Subject: **MODIFICATION to** Request for Modification to the Section 404 Individual Permit and Section 401 Water Quality Certification for the proposed Greensboro Western Loop from north of SR 2176 (Bryan Boulevard) to SR 2303 (Lawndale Drive), Guilford County, Division 7. Federal Aid Project No. STP-NHF-124(1), WBS Element No. 34820.1.2, TIP No. U-2524C and D.

Please see the enclosed revised permit sheets 18, 19 and 25 (of 25). Permit sheets 21-24 are no longer applicable and will be included under TIP U-2525C.

PERMIT DRAWINGS
SHEET 18 OF 25

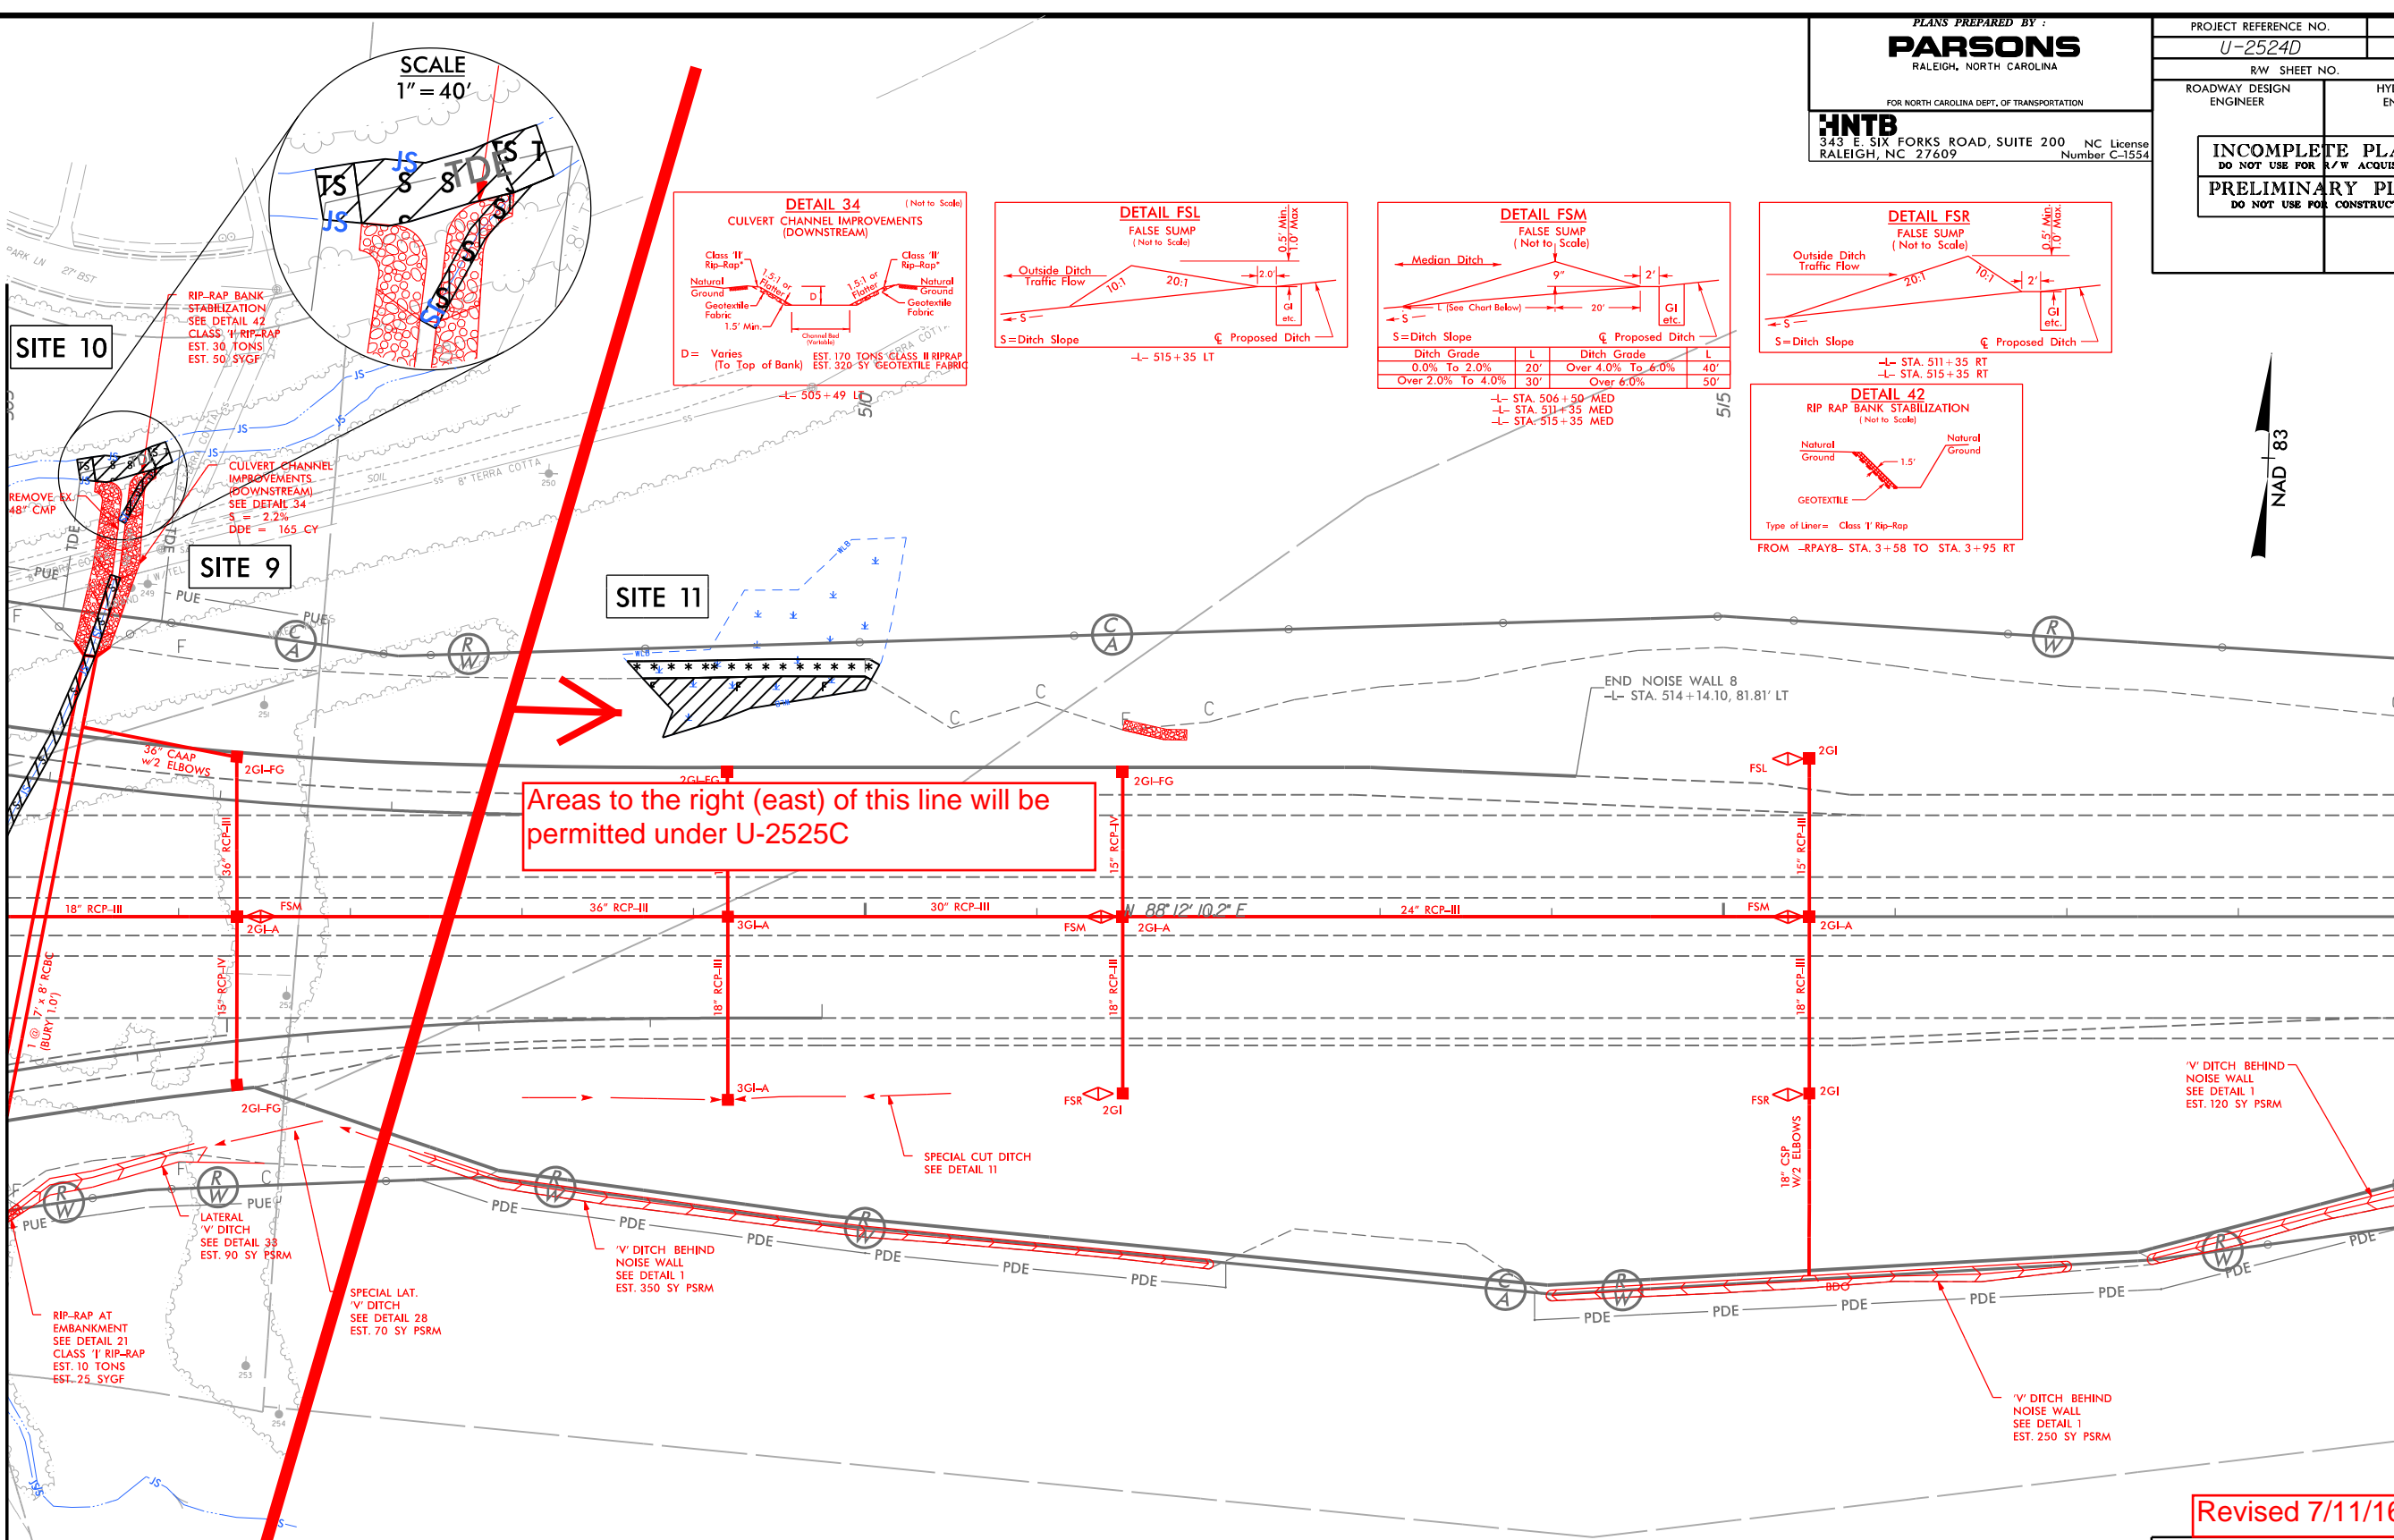
MATCH LINE -L- STA 519+00 SEE SHEET 10A

Areas to the right (east) of this line will be permitted under U-2525C

PERMIT DRAWINGS
SHEET 19 OF 25

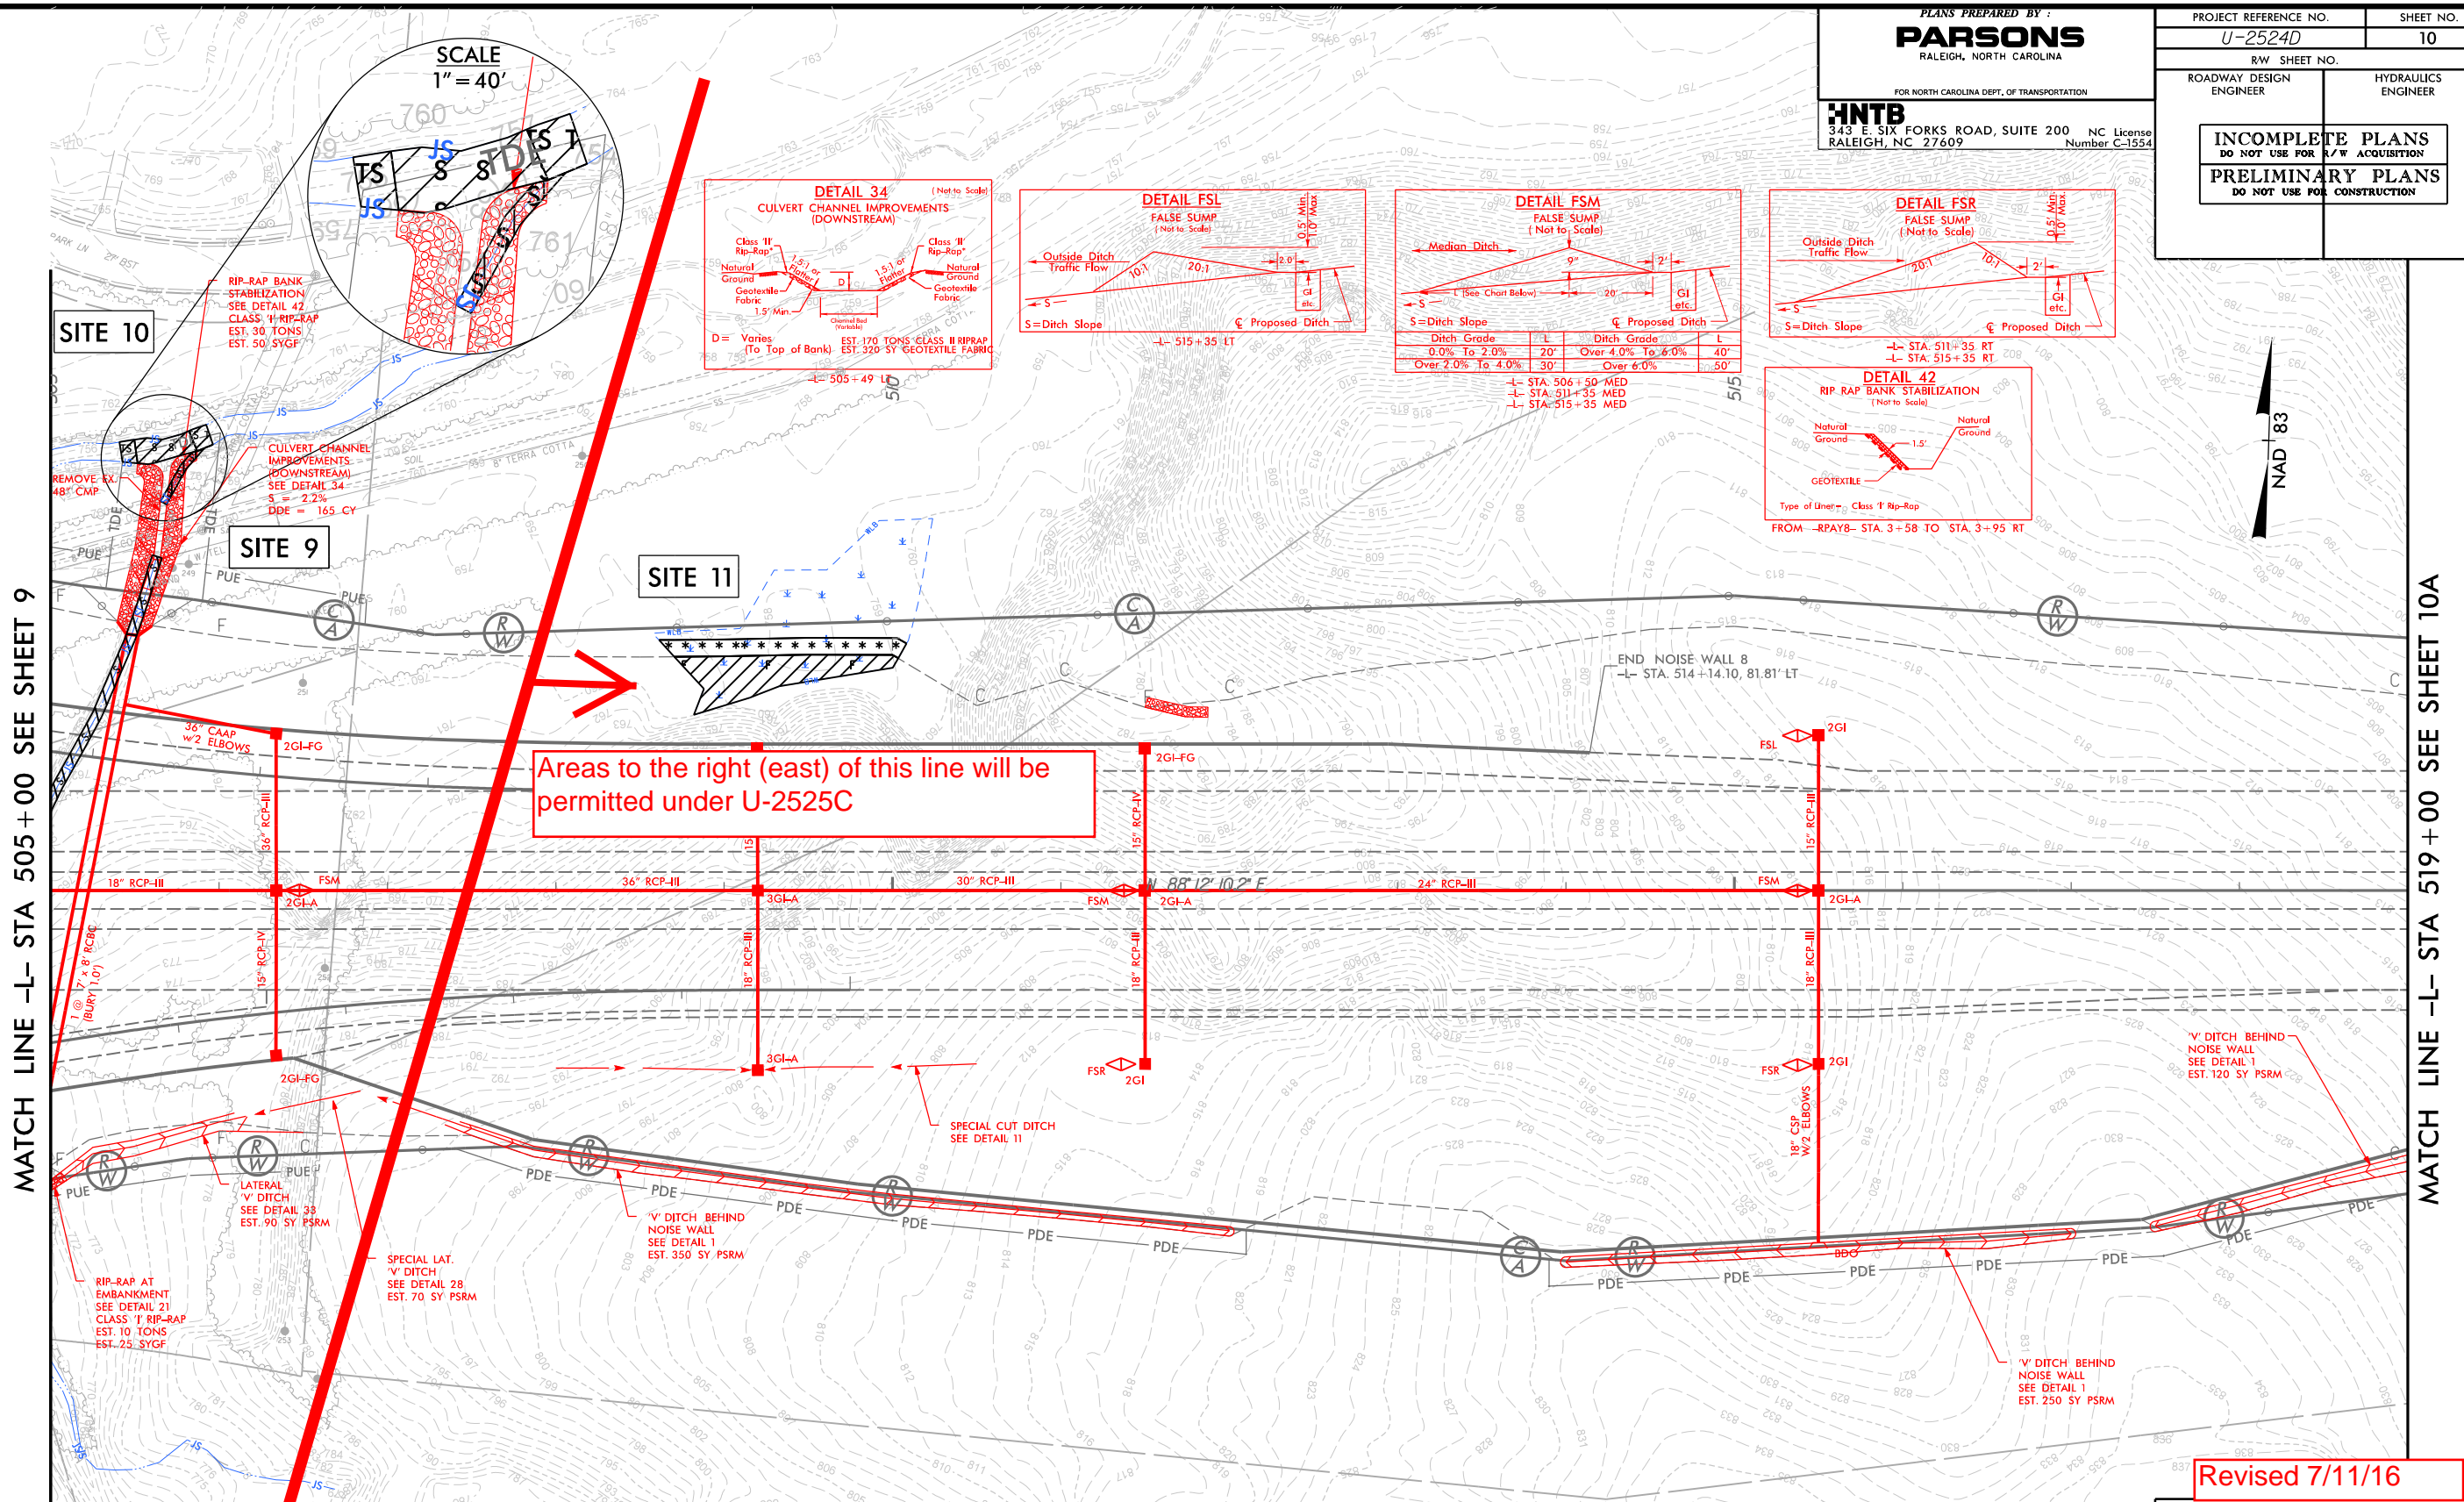
Areas to the right (east) of this line will be permitted under U-2525C
